## Consistency Review Memorandum

**SUBJECT: REDEVELOPMENT PLAN CONSISTENCY REVIEW  
16 PARK AVENUE (BLOCK 23, LOT 9.02)**

Figure 4: Park Avenue Front Setback Pattern (Courtesy of Google)

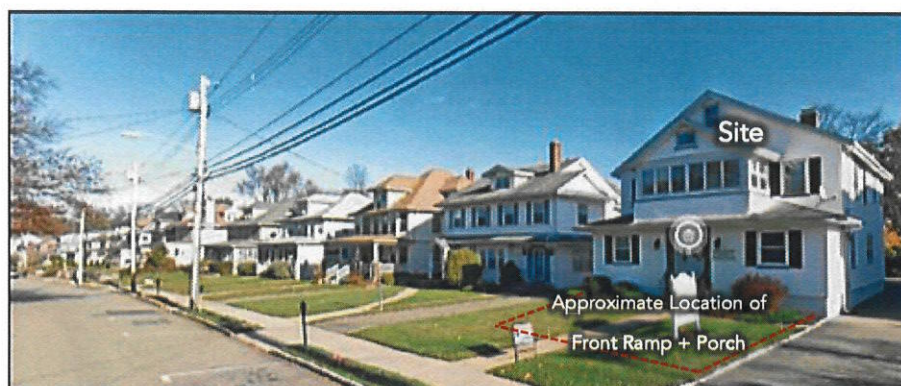
1. **Front + Side Yard Setback (Proposed Ramp):** We offer concern regarding the proposed ~15-20 feet front yard ramp, which creates a front yard and side yard setback deviation. The elevation plans do not depict how this ramp will appear nor depict visual impact on the surrounding houses, which have a clear and established setback pattern (see photo below). We recommend the Prospective Redeveloper consider an alternative design such a mechanical lift, internal

ramping, or shared driveway easement with adjacent owner to relocate the ramp to the side.
